This bulletin is provided for technical reference and service related updates. If you have any questions, comments or do not wish to receive these e-mails, please reply to this

SENSING WIRES

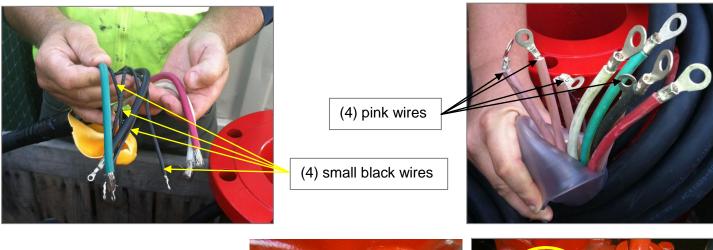
These two submersible pumps are designed with an electrical wire array that provides a certain wire sensing connection option that Multiquip DOES NOT use.

The extra wires for this option can cause confusion when setting up the pump/control box for normal operations.

During the evolution of these two pumps, the sensing wires were changed is size and color (there is no serial number break to define the change).

Reference photos below to identify the un-used sensing wires that need to be capped during installation.

A: these additional sensing wires are **NOT USED** and should be capped.

The (4) wires shown above, need to be capped and secured within the sleeve of the power harness.

NOTE: some wires may be labeled with the letters T, P, or S,
